**Sports Complex**

**1435 Hal Henard Road**

**Assessment October 23, 2018**

**Project:** Greeneville ADA Assessment

**1.13** Is the route stable, firm and slip-resistant?  
[302.1]

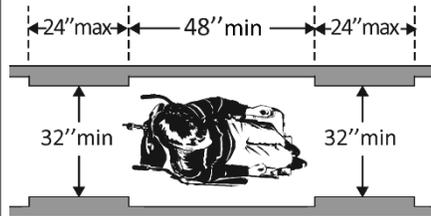
No

- Repair uneven paving
- Fill small bumps and breaks with patches

**2.50** Is there a clear floor space at least 30 inches wide by at least 48 inches long for a forward or parallel approach? [305.3]

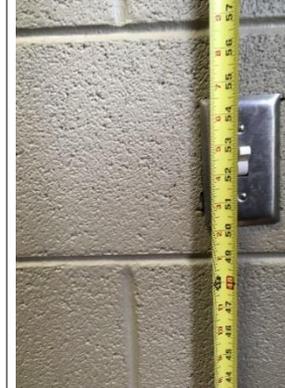
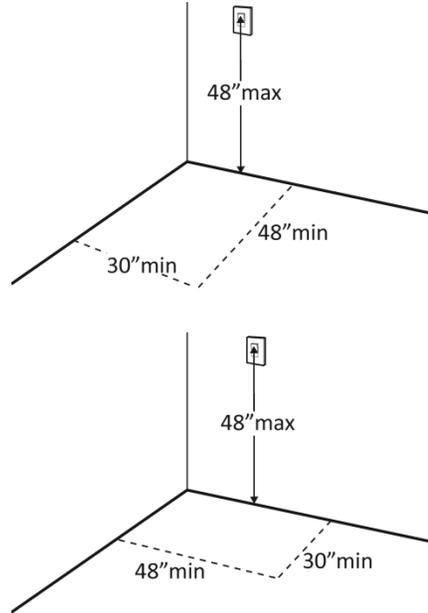
No

Measurement:  
53 inches

Are the operable parts no higher than 48 inches above the floor?\*[309.3, 308]

- Change height of control
- 
-

**2.52** Are an adequate number of wheelchair spaces provided?  
[221.2.1]

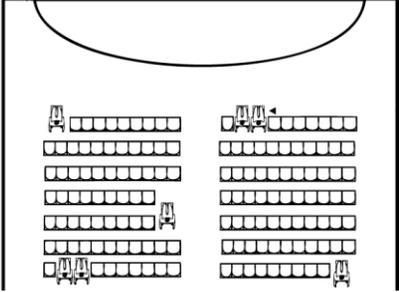
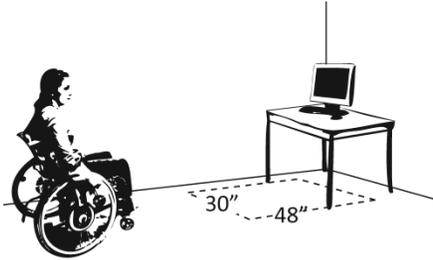
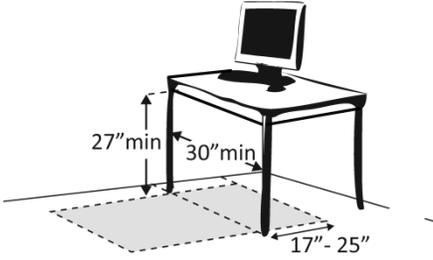
No designated wheelchair spaces

- Designate wheelchair spaces

**3.29** Are the operable parts of the hand dryer or towel dispenser within one of the following reach ranges:

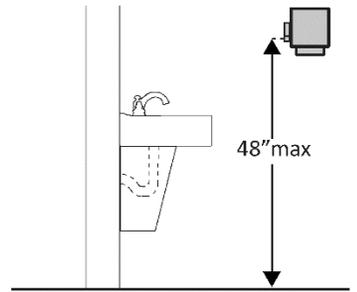
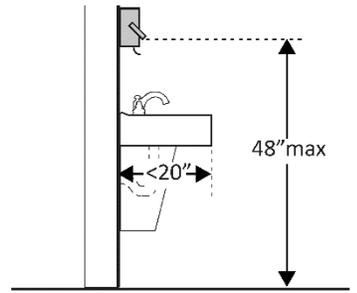
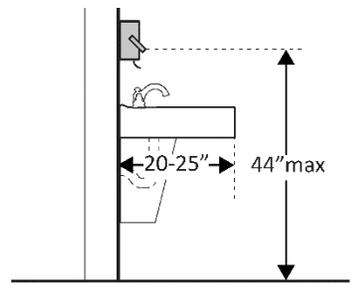
(Women)No  
Measurement:  
+/- 50 inches

(Men)No  
Measurement:

No

- Adjust dispensers
- Replace with or provide additional accessible dispensers
